RESPONSE TO AUDIT ISSUES

APR1400 Topical Reports

Review Section	TR Realistic Evaluation Methodology for LBLOCA of the APR1400
Application Section	Topical Report: APR1400-F-A-TR-12004 Realistic Evaluation Methodology for Large-Break LOCA of the APR1400
Issue Date	08/13/2015

Audit Issues No. 44

Figure 1. Average Core Channel Pressure

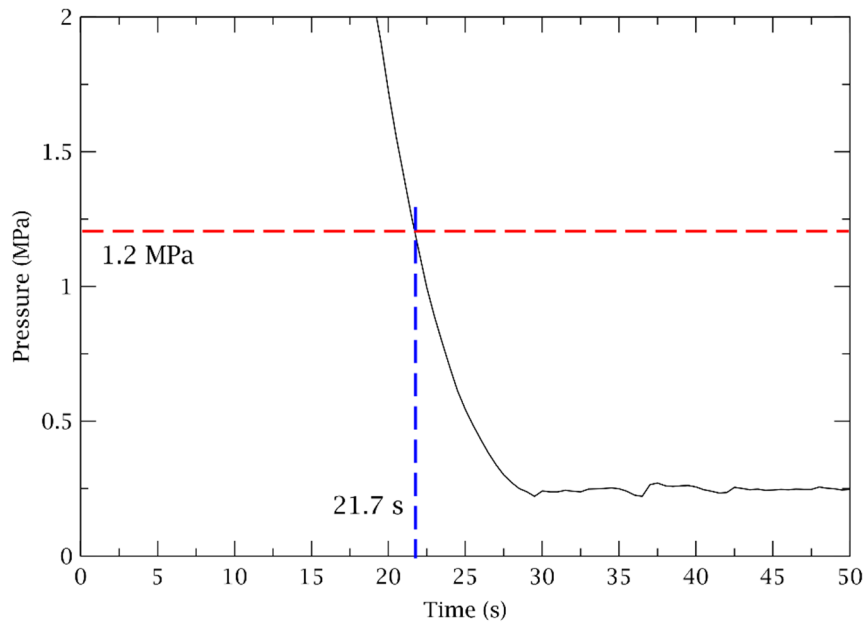
The guidance in RG 1.157, Section 3.12.1 establishes acceptable controls for the calculation of containment pressure. According to "KHNP Responses to Request for Additional Information No. 1-7425" (pg. 7 of 23) for the APR1400 LBLOCA analysis, "...TPEAK is set to 0 (zero) and CONTEMPT4/MOD5 dynamic-link library (contl.dll) is loaded when RELAP5/MOD3.3 starts reflood calculation (reflood heat structures enter to reflood mode). The coupled code sets TPEAK to the time reflood calculation starts." The explanation implies that the coupling between the codes does not commence till the early reflood period. Explain how the containment backpressure is determined and supplied to RELAP5 for the accident period before early reflood.

]^{TS} The loading time is at about 22 s after break in nominal calculation results of APR1400 as shown in Figure 1. Because the early reflood period begins at around 38 s as discussed in Section 3.1.2.3 of topical report, it can be confirmed that CONTEMPT4/MOD5 is loaded during refill period.
